Access Compliance Report Public Rights-of-Way (Curb Ramps)

Main Street: WESTON_PL		Cross Street: LAMBETH_WAY		Location:	SE
ADA ID: RPRK220124123025	Ramp Type: Type 4 - Parallel	Initial Pass/Fail: Fail	Overall Compliance: No	Severity Score:	2
Codes/Mitigation Info/Possible Solution			Field Measurements/Component Compliance

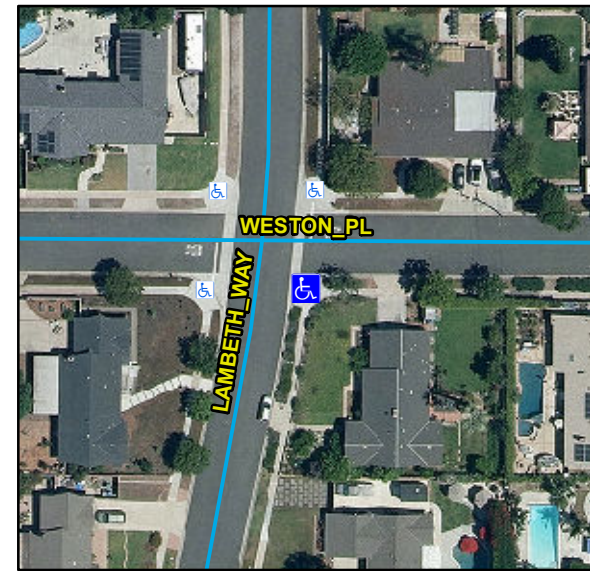
Compliance	Description	Data	Compliance	Description	Data
N/A	Ramp Length LT (in)	91	N/A	Ramp Length RT (in)	90
Yes	Ramp Width LT (in)	121	Yes	Ramp Width RT (in)	121
Yes	Ramp Run Slope LT (%)	7.3	Yes	Ramp Run Slope RT (%)	3.1
No	Ramp Cross Slope LT (%)	4.8	No	Ramp Cross Slope RT (%)	4.7
N/A	Landing Present	N/A	N/A	DWS Provided	N/A
N/A	Landing Length (in)	N/A	N/A	DWS Contrast	N/A
N/A	Landing Width (in)	N/A	N/A	DWS Length (in)	N/A
N/A	Landing Run Slope (%)	N/A	N/A	DWS Full Width	N/A
N/A	Landing Cross Slope (%)	N/A		DWS Offset Type	N/A
N/A	Landing Movement Obstructed?	N/A	N/A	DWS Offset Left (in)	N/A
	Landing Movement Type	N/A	N/A	DWS Offset Right (in)	N/A
N/A	Landing Shared	N/A			
N/A	Clear Space	Yes			
N/A	Clear Space To Crosswalk (in)	N/A			
N/A	Marked Crosswalk 1	No	N/A	Marked Crosswalk 2	No
	Crossing 1 Direction	N		Crossing 2 Direction	W
	Marked Crosswalk 1 Width (in)	N/A		Marked Crosswalk 2 Width (in)	N/A

Remove & Replace Curb Ramp With Two New Directional Ramps or Equivalent.

R304.5.3, STD 1115
